Contract #: 04-0120F4Cty: SF/ALA Rte: 80 PM: 13.2/13.9File #: 69.25B**QUALITY ASSURANCE -- NON-CONFORMANCE REPORT****Location:** Changxing Island, Shanghai, P.R. China**Report No:** NCR-000375**Prime Contractor:** American Bridge/Fluor Enterprises, a JV**Date:** 30-Jul-2009**Submitting Contractor:** Zhenhua Port Machinery Company, Ltd (ZPMC), Changxing Island**NCR #:** ZPMC-0349**Type of problem:**

Reference Description: Missed MT Transverse Indication by QC on Side Panel 3022 (Seg 12CE)**Description of Non-Conformance:**

Job Name: SAS Superstructure

Reference Description: Missed MT Transverse Indication by QC on Side Panel 3022 (Seg 12CE)

项目名称 Project Name	美国海湾大桥 SFOBB	部件图号 Drawing No	SP3022A	报告编号 Report No.	B-WR6628
合同号 Contract No.:	04-0120F4	部件名称 Items Name	OBG SIDE PLATE 12B-D6	NDT报告编号 Report No.of NDT	B787-MT-12546
项目编号 Project No.:	ZP06-787

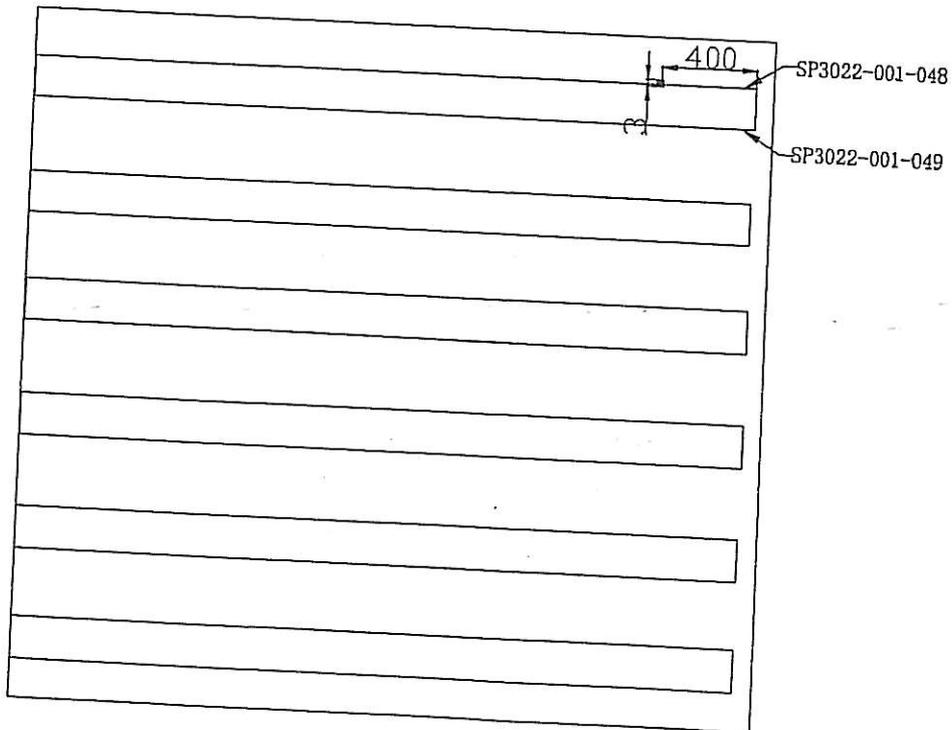
One pore was found by use of MT on SP3022-001-048.
(MT探伤发现1处气孔。)

1. 焊道未及时处理干净。
1. Did not clear the weld pass completely in time.

1. 采用打磨的方法去除气孔;
 2. 焊接前按照焊接返修工艺规程(WPS)准备焊缝接头形式;
 3. 作100%VT与MT检查, 确保缺陷完全去除;
 4. 按照批准的焊缝返修工艺规程(WPS)进行预热和焊接;
 5. 打磨焊缝区域使其与母材平齐;
 6. 对修补区域作100%VT与MT检测;
1. Remove the defects by means of grinding cleanly.
 2. Prepare excavation in accordance with an approved repair WPS prior to welding.
 3. Perform VT 100% of the repair area to insure removal of the defects.
 4. Preheat and weld according to the relevant repair WPS.
 5. Following welding grind the weld flush with base metal.
 6. Perform 100% VT and MT of repair area.

Reference Description: Missed MT Longitudinal Indication by QC on Longitudinal Diaphragm

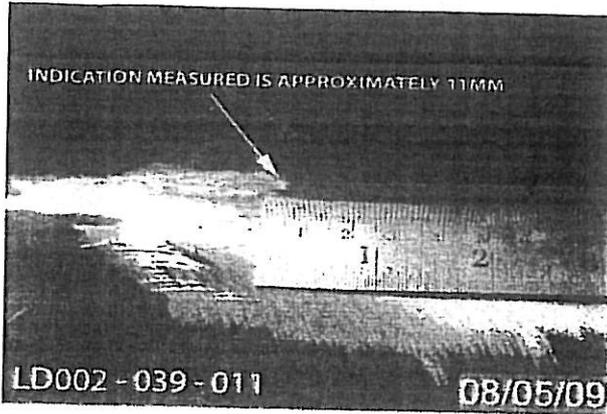
During random verification Magnetic Particle Testing (MT) for the OBG Longitudinal Diaphragms at Bay # 3. The Caltrans Quality Assurance Inspector (QA) observed one (1) longitudinal linear indication approximately 11mm in length in the weld metal on LD002-039-011. Linear Indication was discovered after ZPMC QC MT acceptance.

项目名称 Project Name:	美国海湾大桥 SFOBB	部件图号 Drawing No.:	LD2	报告编号 Report No.:	B-CWR652
合同号 Contract No.:	04-0120F4	部件名称 Item Name:	OBG PLATE PANEL SPLICE	NDT 报告编号 NDT Report No.:	B787-MT-12728
项目编号 Project No.:	ZP06-787

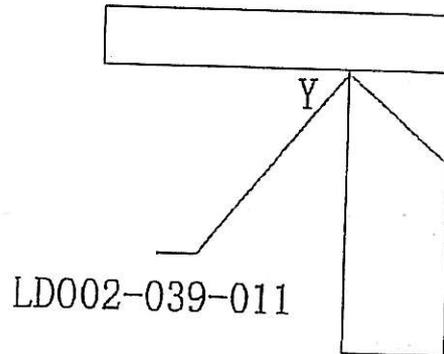
We found one longitudinal crack on the LD002-039-011

Y=2200mm L=20mm

1. Moisture wasn't completely removed during drying operation (preheating) or the area wasn't preheated sufficiently.

1. QC and a Lead CWI shall be present, direct and supervise all grinding and welding operations during this repair to ensure the repair is per the disposition requirements

2. QC and a Lead CWI shall have an approved copy of the CWR in hand prior to the repair.
3. Remove paint $\geq 25\text{mm}$ in all direction of HAZ prior to MT.

4. Remove cracks by grinding, repair area shall extend a minimum of 50mm beyond each end of single crack repairs;
5. If base metal is damaged by grinding, the damaged area shall be ground clean prior to performing weld repair. If gap $> 5\text{mm}$ is found during or after grinding, a separate CWR to make the weld joint a CJP is required in that location, and perform MT after performing grinding the defects away.

6. Prepare excavation in accordance with an approved repair WPS prior to welding.
7. Before this repair, Verify with VT and MT repair areas are defects free;

8. Perform MT on the weld metal adjacent to the repair area to ensure that crack did not propagate into base metal. If crack is discovered in base metal, approval of a separate CWR is required before continuing with repair work.

9. Preheat and weld according to the approved repair WPS.
10. Grind the repaired area flush with base metal or the adjacent weld.
11. Perform 100%VT and MT inspection to all repaired welds (along with an additional 50mm at each end of the weld repair) which include the near side and far side on the upper Perform UT and MT inspection to CJP weld.
